Merimbula Transport Study – CBD Landscape Masterplan Assessment

The Merimbula Transport Study identifies a number of recommendations to improve Movement and Place outcomes for the town, considering the needs of all transport users, now and in the future. Some of the recommendations however are not in alignment with the CBD Landscape Masterplan. This document outlines any alignment and conflicts, and describes how the CBD Landscape Masterplan may be amended to better align with the Transport Study outcomes.

2.5.3 Main Street / Market Street Precinct

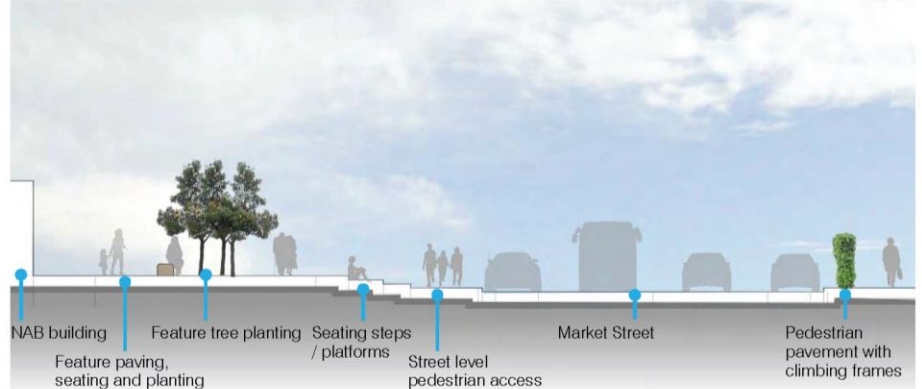
NOTE: Roundabout is not viable at this intersection due to road cross fall. Consider alternative intersection arrangements to improve traffic flow and pedestrian connectivity and safety.

ID	Merimbula CBD Masterplan Recommendations	Alignment with Merimbula Transport Study (TS) Report Recommendations	Recommended updates to Merimbula CBD Masterplan (if recommendation conflicts with the TS report)
1	Provide feature trees at focal point and highlight entry to Market Street.	Consistent with Recommendation #P6.	-
2	Improve vehicle and pedestrian safety at intersection through installation of traffic signals at this intersection.	Consistent with Recommendation #R3.	-
3	Extend kerbs and pavement to narrow crossing distance and improve pedestrian safety.	Consistent with Recommendation #R3 and supports Recommendation #P12.	-
4	Provide garden beds, trees and furniture to extended pavement.	Consistent with Recommendation #P6 and contributes to enhanced place-making.	-
5	Provide street planting in climber on frame for improved visual and pedestrian amenity.	No conflict with the TS Recommendations.	-

6	Retain existing brick paving. Work with shop landlords and tenants to remove steps to shop fronts and provide internal ramp access.	Supports Recommendation #P7. No conflicts with TS Recommendations.	-
7	Retain existing parallel parking arrangements.	Conflict with Recommendation #P9.	Recommended to incorporate #P9 ie "Increase verge space and provide alfresco dining opportunities on Market Street between Beach Street and Main Street.

2.5.4 Merimbula Drive / Market Street Precinct

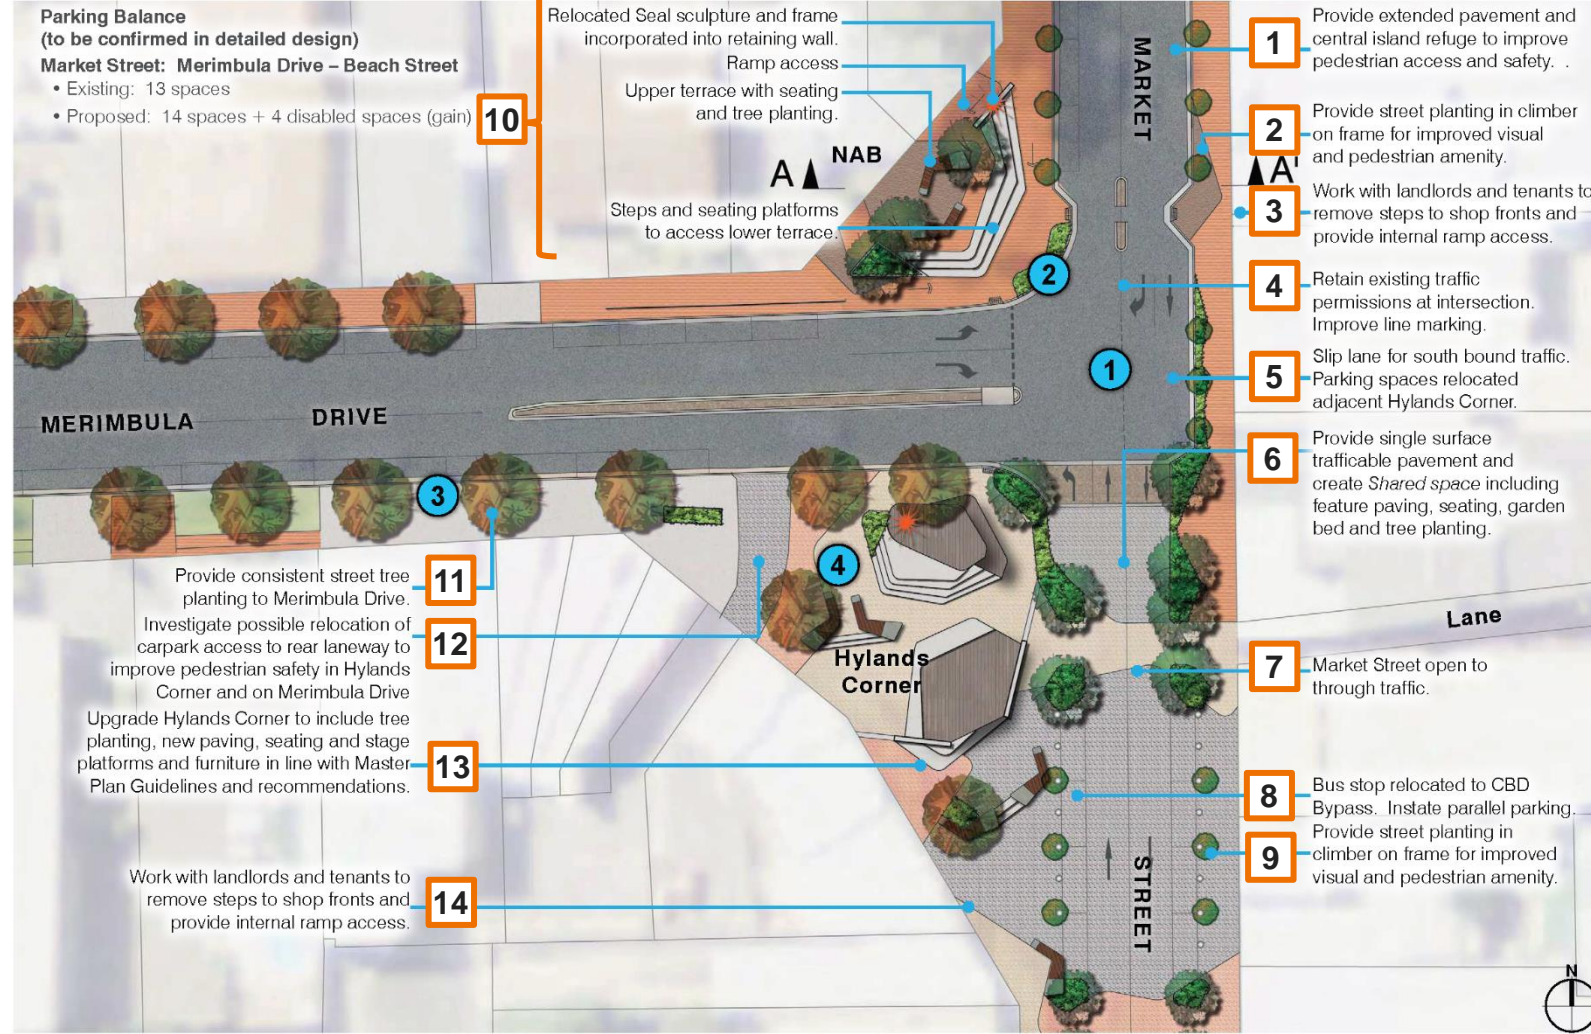
ID	Merimbula CBD Masterplan Recommendations	Alignment with Merimbula Transport Study (TS) Report Recommendations	Recommended updates to Merimbula CBD Masterplan (if recommendation conflicts with the TS report)
1	Provide extended pavement and central island refuge to improve pedestrian access and safety.	TS report proposes the provision of Disability Discrimination Act compliant wombat crossing as part of Recommendation #A3. Supports Recommendation #P12.	Incorporate Recommendation #A3 by providing a raised wombat crossing at this location. Wombat crossing provides better pedestrian priority than refuge crossing.
2	Provide street planting in climber on frame for improved visual and pedestrian amenity.	No conflict with the TS Recommendations.	-
3	Work with landlords and tenants to remove steps to shop fronts and provide internal ramp access.	Supports Recommendation #P7.	-
4	Retain existing traffic permissions at intersection. Improve line marking.	Not in alignment with Recommendation #P1 and Transformative Idea #1 which proposes one-way southbound vehicular traffic flow on Market Street between Merimbula Drive and Palmer Lane.	Incorporate the proposed vehicle movement configuration option as part of Transformative Idea #2 and Recommendation #P1 to create one-way southbound vehicular traffic flow on Market Street between Merimbula Drive and Palmer Lane.

5	Slip lane for south bound traffic. Parking spaces relocated adjacent Hylands Corner.	Not part of the TS report recommendations; no conflict with the TS report recommendations, however the proposed parking spaces relocated adjacent to Hylands Corner should be prioritised for those who need it most such as people with mobility issues and those with short term drop-off and pick-up needs as noted in Section 2.5 of the TS report.	-
6	Provide single surface trafficable pavement and create shared space including feature paving, seating, garden bed and tree planting.	Not in alignment with Recommendation #A2 (30km/hr slow speed zone).	Suggest to remove shared space on Market Street because of location of southbound bus route which may cause interactions with pedestrians. Maintain slow speed zone of 30km/hr in this location.
7	Market Street open to through traffic.	Not in alignment with Recommendation #P1 and Transformative Idea #2 which propose one way southbound vehicular traffic flow on Market Street between Merimbula Drive and Palmer Lane.	Incorporate the proposed vehicle movement configuration option as part of Transformative Idea #2 and Recommendation #P1 to create one-way southbound vehicular traffic flow on Market Street between Merimbula Drive and Palmer Lane.

8	Bus stop relocated to CBD Bypass. Instate parallel parking.	The relocation of bus stop to CBD Bypass supports the re-routing of 890 and 891 northbound buses via Merimbula Drive as part of Transformative Idea #2 and Recommendation #P1 (TS report). The instatement of parallel parking at this location might potentially conflict with Recommendation #P12; it should be noted that Section 2.5 of the TS report states that CBD parking is to be prioritised for those who need it most such as people with mobility issues and those with short term drop-off and pick-up needs.	Consider Recommendation #P12 (TS report) in terms of constricting road widths to provide either more space for people or disabled parking.

ID	Merimbula CBD Masterplan Recommendations	Alignment with Merimbula Transport Study (TS) Report Recommendations	Recommended updates to Merimbula CBD Masterplan (if recommendation conflicts with the TS report)
9	Provide street planting in climber on frame for improved visual and pedestrian amenity.	No conflict with the TS Recommendations.	-
10	Upper terrace with seating and tree planting. Provide ramp and direct step access to lower terrace, street and aligned pedestrian crossing location. Steps and seating platforms to access lower terrace. Relocated Seal sculpture and frame incorporated into retaining wall.	The upgrade of NAB Corner is not part of the TS report recommendations however does not conflict with the TS report recommendations. The inclusion of proposed ramp access is in line with Recommendation #P7.	-
11	Provide consistent street tree planting to Merimbula Drive.	Consistent with Recommendation #P6.	-

12	Investigate possible relocation of carpark access to rear laneway to improve pedestrian safety in Hylands Corner and on Merimbula Drive.	No conflict with the TS report recommendations.	-
13	Upgrade Hylands Corner to include tree planting, new paving, seating and stage platforms and furniture in line with Master Plan Guidelines and recommendations.	Consistent with Recommendation #P10.	-
14	Work with landlords and tenants to remove steps to shop fronts and provide internal ramp access.	Supports Recommendation #P7.	-

2.5.5 Market Street / Beach Street Precinct

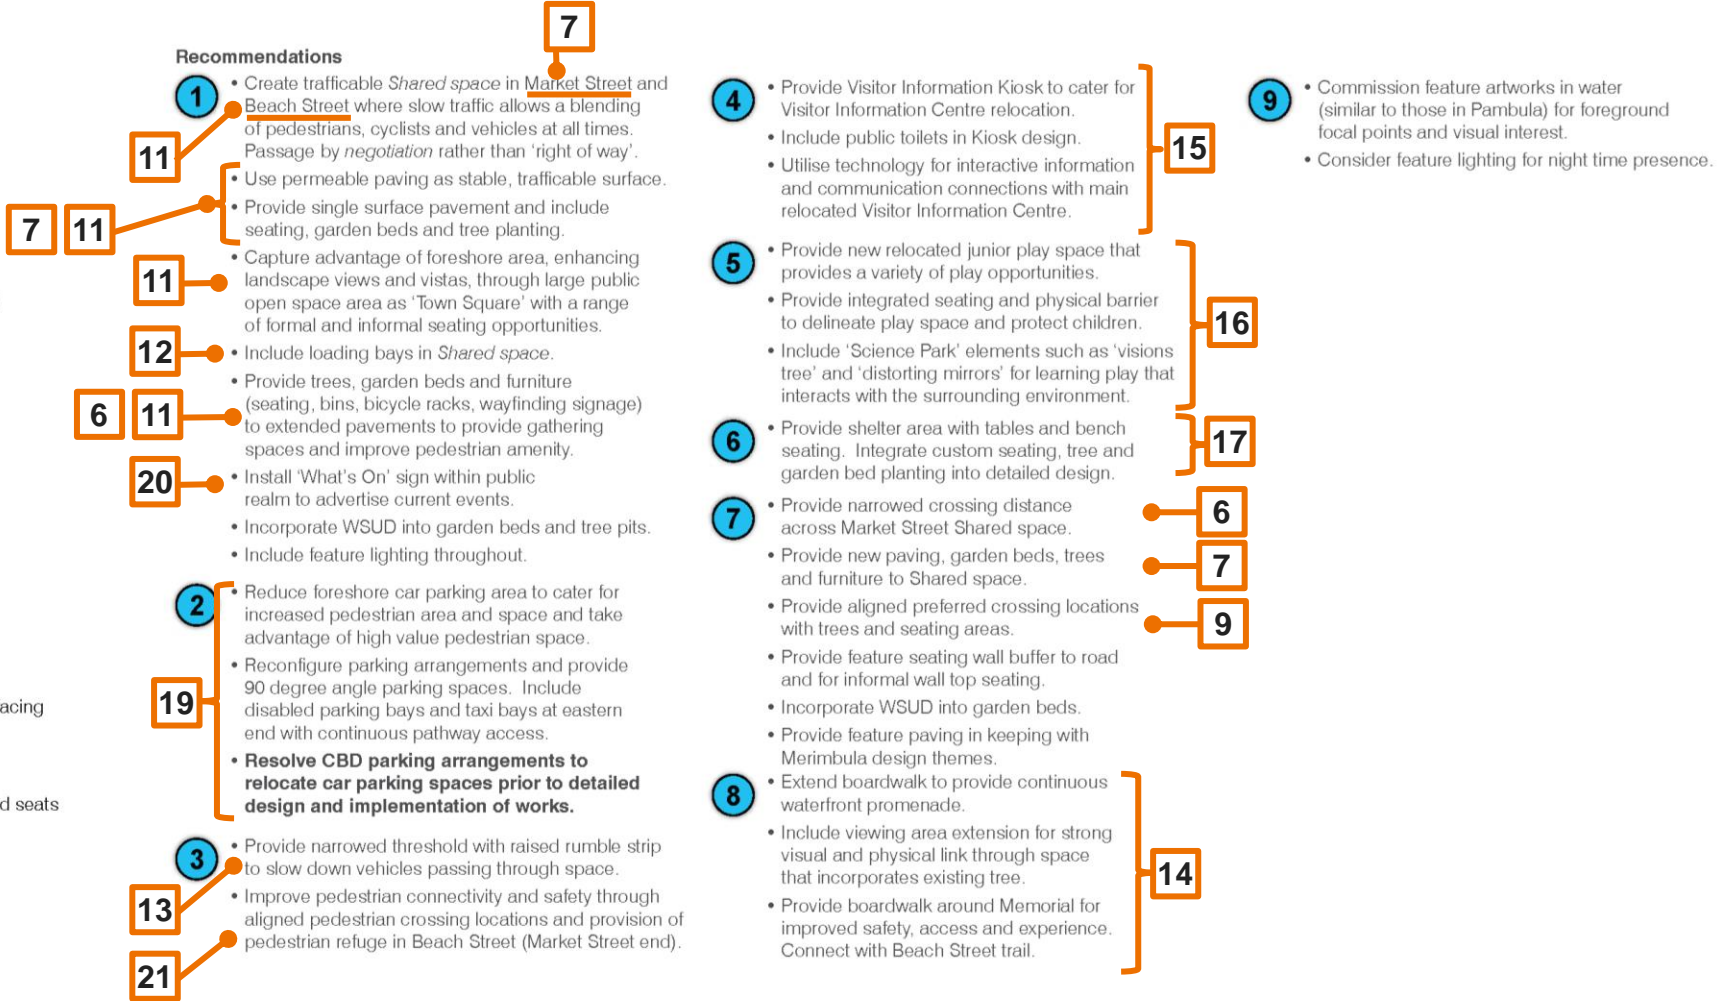
ID	Merimbula CBD Masterplan Recommendations	Alignment with Merimbula Transport Study (TS) Report Recommendations	Recommended updates to Merimbula CBD Masterplan (if recommendation conflicts with the TS report)
1	Provide street planting in climber on frame for improved visual and pedestrian amenity.	No conflict with the TS report recommendations.	-
2	Retain seating area, raised garden bed and planting.	No conflict with the TS report recommendations.	-
3	Market Street open to through traffic.	Not in alignment with Recommendation #P1 and Transformative Idea #2 which propose one way southbound vehicular traffic flow on Market Street between Merimbula Drive and Palmer Lane.	Consider the proposed vehicle movement configuration option as part of Transformative Idea #2 and Recommendation #P1 to create one-way southbound vehicular traffic flow on Market Street between Merimbula Drive and Palmer Lane.

4	Beach Street open to through traffic.	Not in alignment with Recommendation #P1 and Transformative Idea #2 which propose one way eastbound vehicular traffic flow on Beach Street.	Incorporate the proposed vehicle movement configuration option as part of Transformative Idea #2 and Recommendation #P1 to create one-way southbound vehicular traffic flow on Market Street between Merimbula Drive and Palmer Lane.
5	No right turn into Market Street from Beach Street to improve traffic flow.	Not in alignment with Recommendation #P1 and Transformative Idea #2 whereby northbound movements are not permitted at the intersection of Beach Street and Market Street.	Incorporate the proposed vehicle movement configuration option as part of Transformative Idea #2 and Recommendation #P1 to create one-way southbound vehicular traffic flow on Market Street between Merimbula Drive and Palmer Lane.
6	Extend pedestrian pavement to narrow crossing distance. Provide new paving, garden beds, trees and furniture to extended pavement.	Supports Recommendation #P12.	-

7	Provide single surface trafficable pavement and create shared space including feature paving, seating, garden bed and tree planting.	Not in alignment with Recommendation #A2 (30km/hr slow speed zone).	Suggest to remove shared space on Market Street because of location of southbound bus route which may cause interactions with pedestrians. Maintain slow speed zone of 30km/hr in this location.
8	Work with shop landlords and tenants to remove steps to shop fronts and provide internal ramp access.	Supports Recommendation #P7.	-
9	Remove existing pedestrian lights to allow for shared space. Signify preferred crossing locations with paving and tree planting.	Not in alignment with Recommendation #A5 (provide raised pedestrian crossing).	Suggest to remove shared space on Market Street because of location of southbound bus route which may cause interactions with pedestrians. Provide raised wombat crossing in this location.

10	Relocate Bus stop to CBD Bypass. Instate disabled parking bays.	Southbound bus route does not need to be re-routed to the CBD Bypass (as per Transformative Idea #2 and Recommendation #P1).	Consider retaining the bus stop for southbound bus routes at this location and provide disabled parking spaces north of the bus stop as per Recommendation #PA3.

ID	Merimbula CBD Masterplan Recommendations	Alignment with Merimbula Transport Study (TS) Report Recommendations	Recommended updates to Merimbula CBD Masterplan (if recommendation conflicts with the TS report)
11	Provide single surface trafficable pavement and create shared space including seating, garden bed and tree planting.	Consistent with Recommendation #A2; supports Recommendation #P4 and Transformative Idea #3. Traffic movements on Beach Street not consistent with #P1 and Transformative Idea #2.	Traffic movement to be modified to be consistent with Transformative Idea #2 ie one-way eastbound movement on Beach Street. Retain shared space on Beach Street. Shared zone on Beach Street between Market Street and Alice Street to be 10km/hr speed limit.
12	Provision of loading bays.	No conflict with the TS report recommendations.	-
13	Narrowed threshold with raised rumble strip to slow down vehicles passing through space.	No conflict with the TS report recommendations. Supports Recommendation #A2.	-

14	Extend boardwalk to provide continuous waterfront promenade. Provide boardwalk around Memorial for improved safety, access and experience. Connect with Beach Street trail.	Supports the Transformative Idea #1.	-
15	Provide Visitor Information Kiosk to cater for Visitor Information Centre relocation. Include public toilets in Kiosk design.	Consistent with Recommendation #P4 and Transformative Idea #3; Supports Recommendation #P2.	-
16	Provide new relocated junior play space that provides a variety of play opportunities. Provide integrated seating and physical barrier to delineate play space and protect children.	Consistent with Recommendation #P4 and Transformative Idea #3.	-
17	Provide shelter area with tables and bench seating.	Consistent with Recommendation #P4 and Transformative Idea #3.	-
18	Enhance waterfront amenity with signature tree planting.	Consistent with Recommendation #P4 and Recommendation #P6.	-

19	Reconfigure parking arrangements to allow for public open space in high value foreshore land. Provide 90 degree angle parking spaces. Include disabled parking bays at eastern end and continuous pathway access.	Proposed parking configuration is not in alignment with Recommendation #P4 and Transformative Idea #3.	Incorporate proposed parking arrangements as per Recommendation #P4 and Transformative Idea #3 ie 45 degree angled parking on northern side of Beach Street.
20	Install 'What's On' sign within public realm to advertise current events.	Supports Recommendation #P2.	-
21	Improve pedestrian connectivity and safety through aligned pedestrian crossing locations and provision of pedestrian refuge in Beach Street (Market Street end).	Aligns with Recommendation #P1 and Transformative Idea #2 – propose one-way eastbound vehicular traffic flow on Beach Street.	Recommend not to have a pedestrian refuge within a shared zone, because this treatment gives priority to vehicles. Shared zone gateway treatments are recommended, pedestrians may cross anywhere within a shared zone.

2.5.6 Market Street / Monaro Street Precinct

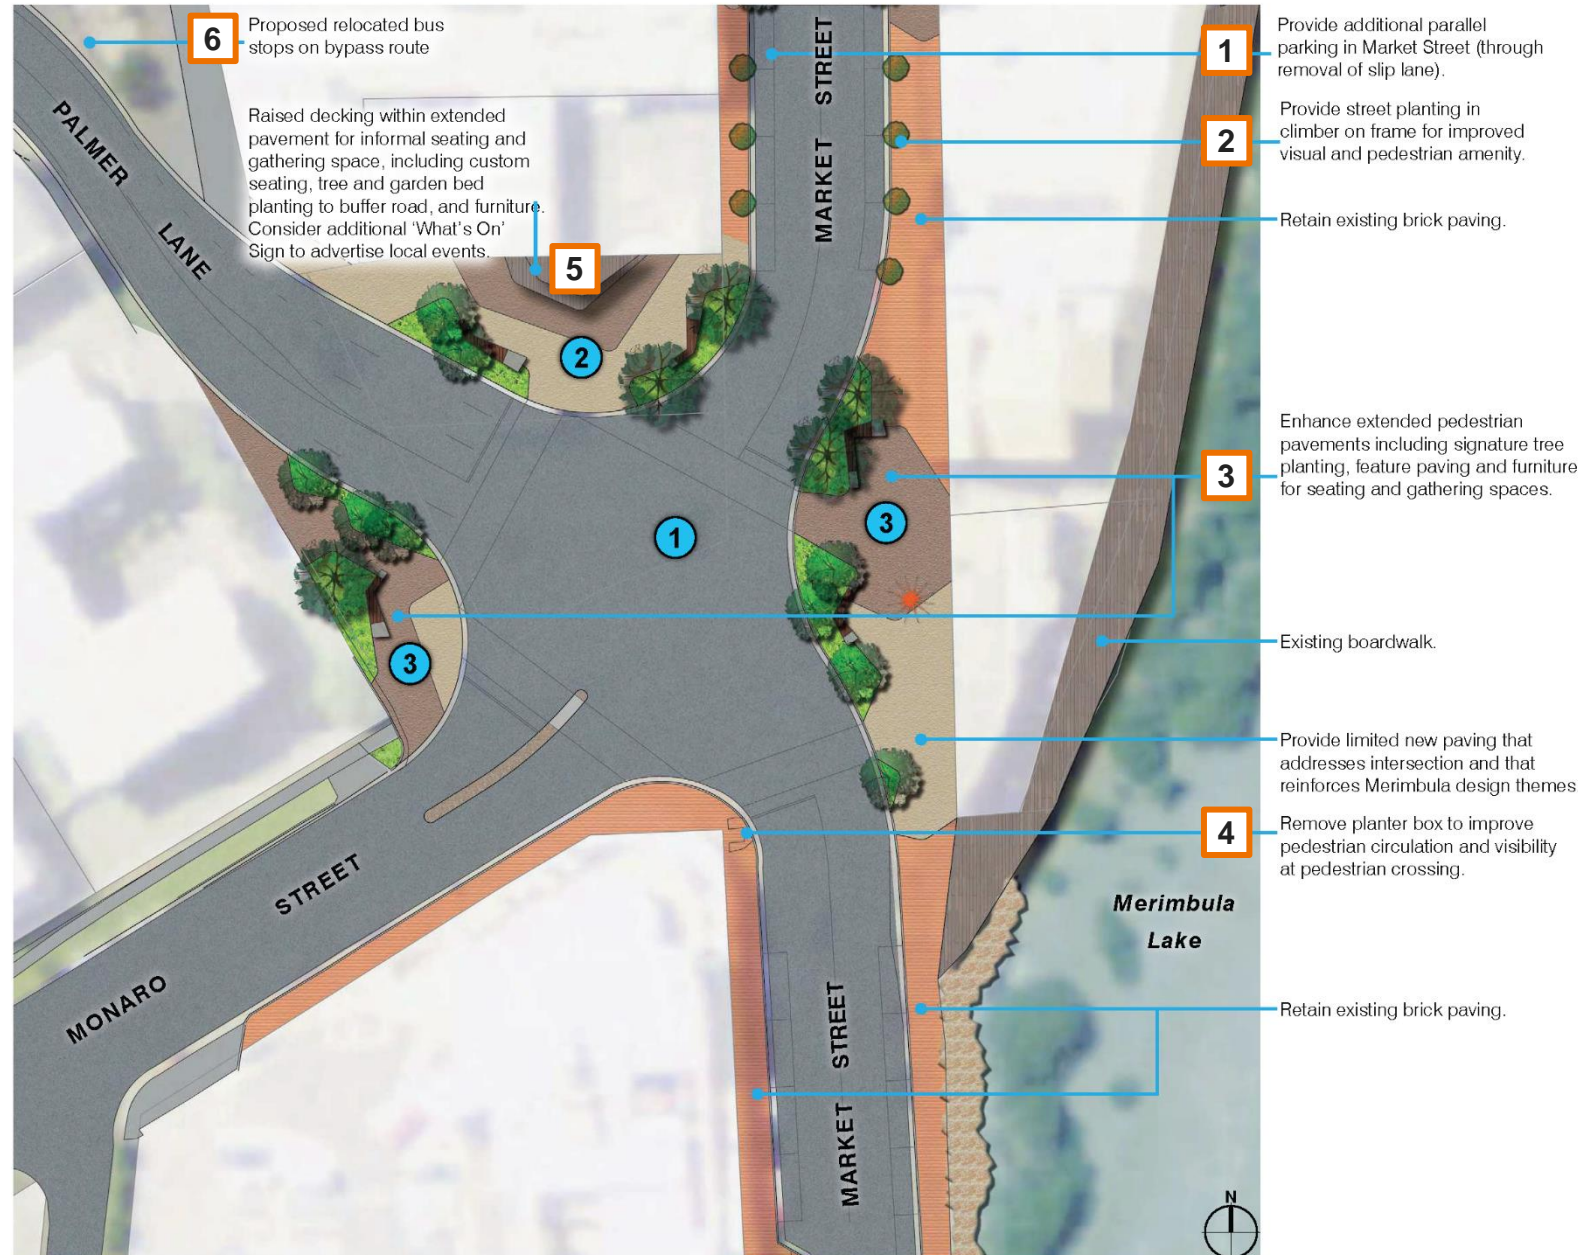
ID	Merimbula CBD Masterplan Recommendations	Alignment with Merimbula Transport Study (TS) Report Recommendations	Recommended updates to Merimbula CBD Masterplan (if recommendation conflicts with the TS report)
1	Provide additional parallel parking in Market Street (through removal of slip lane).	Not part of the TS report recommendations; it should be noted that Section 2.5 of the TS report states that CBD parking is to be prioritised for those who need it most such as people with mobility issues and those with short term drop-off and pick-up needs Potential conflict with Recommendation #P12.	Incorporate recommendation #P12 in terms of constricting road widths to provide either more space for people or disabled parking.
2	Provide street planting in climber on frame for improved visual and pedestrian amenity.	No conflict with the TS report recommendations.	-
3	Enhance extended pedestrian pavements including signature tree planting, feature paving and furniture for seating and gathering spaces.	Supports Recommendation #P12.	-

4	Remove planter box to improve pedestrian circulation and visibility at pedestrian crossing.	Supports Recommendation #R3.	-
5	Raised decking within extended pavement for informal seating and gathering space, including custom seating, tree and garden bed planting to buffer road, and furniture. Consider additional 'What's On' Sign to advertise local events.	Supports Recommendation #P12 and consistent with #P2.	-
6	Proposed relocated bus stops on bypass route.	Bus stop(s) on southern side of Park Street: supports the re-routing of 890 and 891 northbound buses via Merimbula Drive as part of Transformative Idea #2 and Recommendation #P1. Bus stop(s) on northern side of Park Street: existing southbound regular public bus routes do not travel through Park Street and these bus routes do not need to be re-routed as part of Transformative Idea #2 and Recommendation #P1.	Consider the instatement of bus stops on southern side of Park Street only (in the case that only the northbound buses are re-routed).

7	Intersection modified to cater for CBD Bypass including traffic lights.	Consistent with Recommendation #R2.	-
